Access Compliance Report Public Rights-of-Way (Curb Ramps)

Main Street: BEACH_BLVD Cross Street: MCFADDEN_AVE Location: SW

ADA ID: RPRK211005145439 Ramp Type: Type 1 - Perpendicular Diagonal Initial Pass/Fail: Fail Overall Compliance: No Severity Score: 15

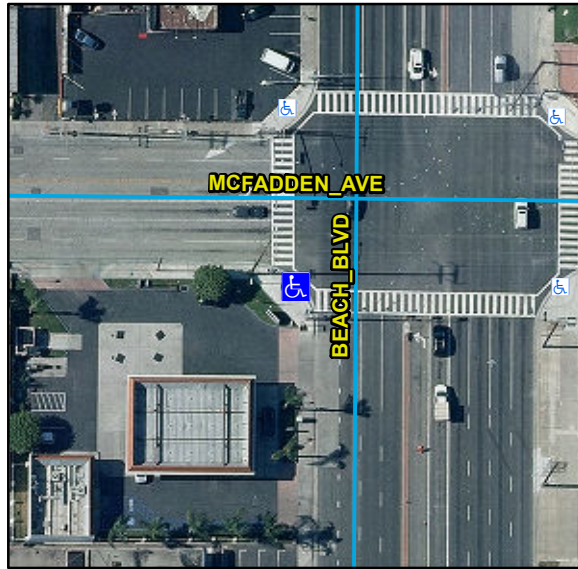
Compliance	Description	Data	Compliance	Description	Data
N/A	Ramp Length (in)	84	N/A	Flare Type LT	
Yes	Ramp Width (in)	48			N/A
Yes	Ramp Run Slope (%)	6.4	N/A	Flare Slope LT (%)	N/A
No	Ramp Cross Slope (%)	6.5	N/A	Flare Traversable LT	N/A
N/A	Landing Present	N/A	N/A	Flare Type RT	
N/A	Landing Length (in)	N/A			N/A
N/A	Landing Width (in)	N/A	N/A	Flare Slope RT (%)	N/A
N/A	Landing Run Slope (%)	N/A	N/A	Flare Traversable RT	N/A
N/A	Landing Cross Slope (%)	N/A	N/A	DWS Provided	N/A
N/A	Landing Movement Obstructed?	N/A	N/A	DWS Contrast	N/A
	Landing Movement Type	N/A	N/A	DWS Length (in)	N/A
N/A	Landing Shared	N/A	N/A	DWS Full Width	N/A
N/A	Clear Space	Yes	N/A	DWS Offset Left (in)	N/A
N/A	Clear Space To Crosswalk (in)	48	N/A	DWS Offset Right (in)	N/A
N/A	Marked Crosswalk 1	Yes	N/A	Marked Crosswalk 2	Yes
	Crossing 1 Direction	E		Crossing 2 Direction	N
	Marked Crosswalk 1 Width (in)	140		Marked Crosswalk 2 Width (in)	140

N/A	Ramp Inside Crosswalk 1	No	Yes	Ramp Inside Crosswalk 2	No
	Crossing 1 Slope (%)	8.5		Crossing 2 Slope (%)	1.7
	Crossing 1 Cross Slope (%)	1.4		Crossing 2 Cross Slope (%)	7.2
N/A	Gutter Ponding	N/A	No	Curb Slope	5.5
Yes	Gutter Lip Height (in)	0		Road Run Slope (%)	5.5
N/A	Gutter Run Slope (%)	N/A		Road Cross Slope (%)	6.7
N/A	Gutter Cross Slope (%)	N/A			
Yes	Overall Surface Condition: Acceptable		Yes	Perp Joint Present	Yes
	Cross Gutter Present?	No		Spandrel Present?	No
	Replace Cross Gutter?	N/A		Replace Spandrel?	N/A

Remove & Replace Curb Ramp With Two New Directional Ramps or Equivalent. Restripe Crosswalk.
